REGULATION BULLETIN #2

Registration Plates

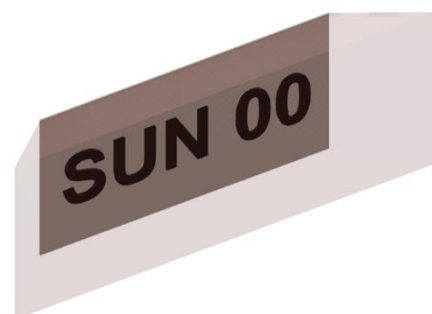
Regulation 2.6.2 says that the letters on the registration plate must be “upright”. This means that the short edge of the registration plate must be perpendicular to the ground.

The four images below show the rear view, side view, top view, and tilted view of the registration plate and the region around it that must not contain any part of the solar car.
